# COMMENTS AND RESPONSE REPORT

## THE PROPOSED RESIDENTIAL DEVELOPMENT ON REMAINDER OF PORTION 21 OF FARM 195 KRAAIBOSCH (PIETER KOEN TRUST), GEORGE, WESTERN CAPE.

*Street view facing eastwards illustrating the comparative building heights on either side of the road.*

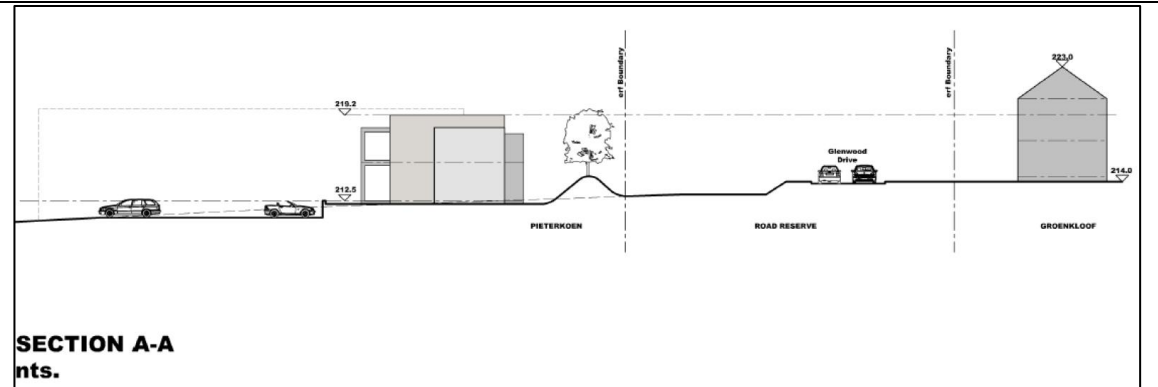
The following two options were considered as alternatives in response to the comments received about the visual impact of the proposed 3-storey apartment complex in the south-east corner of the property.

The object of the exercise was to investigate the possibility of reconfiguring the apartment buildings as a more compact set of 3-storey buildings and to reduce the overall visual impact by excavating the site to a level well below the road level.

<p>Option A addresses the issue of building heights but is not considered to be a viable option as the associated costs of excessive site excavations and having to complete a large number of sectional apartments in a consolidated block before the titles can be registered, impact very negatively on the cash flow and viability of the development. Practical problems such as insufficient space for the required parking, apartments not optimally orientated for views and sunlight and lack of private open space around the buildings, will all be factors that will affect the marketability of the apartments negatively. Option A is therefore not a viable alternative.</p> <p><b>OPTION B</b></p> <p>This option considers the reduction of the total number of apartments, reducing the building heights of apartment blocks facing Glenwood Road to 2-storeys, introducing screening elements between the buildings and the street boundary as proposed in the specialist VIA and maintaining a ridge height of all the apartment blocks to a level well below the highest 2-storey building in the Groenkloof “Hub”.</p> <p>The result of this alternative proposal is that the apartment units are reduced from 84 to 66. However, for the development to remain financially viable, the layout and number of town houses must be increased from 44 erven to 50 erven. This means that the total number of housing opportunities in the development is reduced from 312 to 300 – a loss of 12 opportunities.</p> <p>An application for an amendment of the town house (Portion A1) subdivision will have to be lodged with the municipal town planning department.</p> <p>The Option B site layout is shown below. Portion A1 illustrates the amended site layout for a 50-erf subdivision as opposed to the 44 erven currently being applied for.</p> <p>Portion A2 shows the sectional title erf with 3 centrally spaced 2-storey apartment blocks housing 4 units per block parallel to the road boundary. The blocks have been placed well outside the street boundary to allow for an earth berm planted with trees and shrubs as a screening tool to soften the visual impact of the buildings from the road.</p>

Site layout showing Option B Portion A1 (town houses) and Portion A2 (apartments).

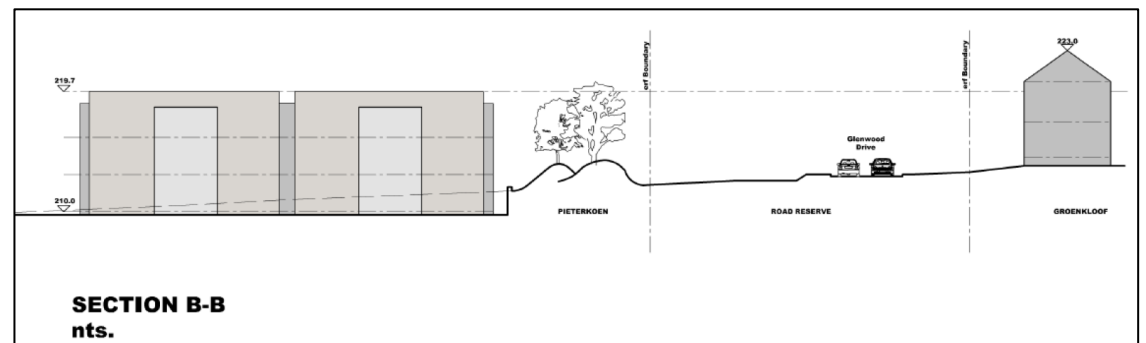
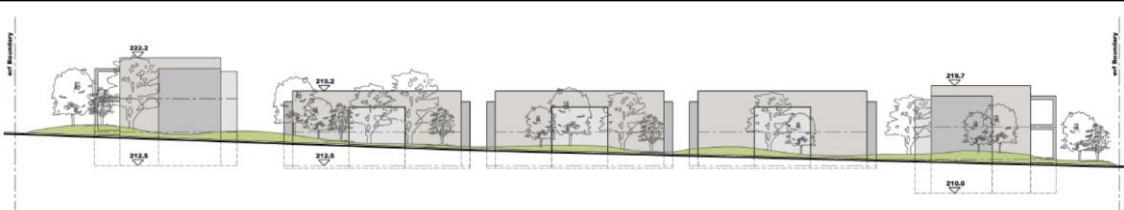
The two rows of four 3-storey blocks orientated along the two side boundaries are placed on reduced ground levels to ensure that no building height in this portion exceeds the maximum ridge height of the buildings in the Groenkloof “Hub”. Similar screening tools will be used on the road boundary.

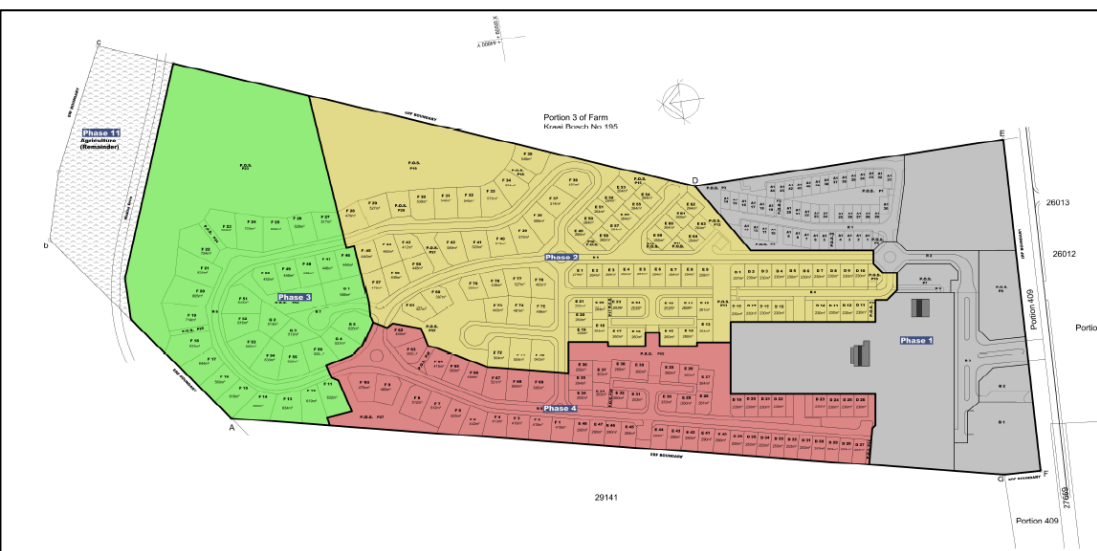
2-Storey apartment blocks along the street boundary showing the planted berm and relative roof heights. (Glenwood Road before recent upgrades and widening).

3 - Storey apartments orientated south to north along the eastern erf boundary showing the reduced ground level, planted berm and relative roof heights. (Partial elevation, Glenwood Road before recent upgrades and widening).
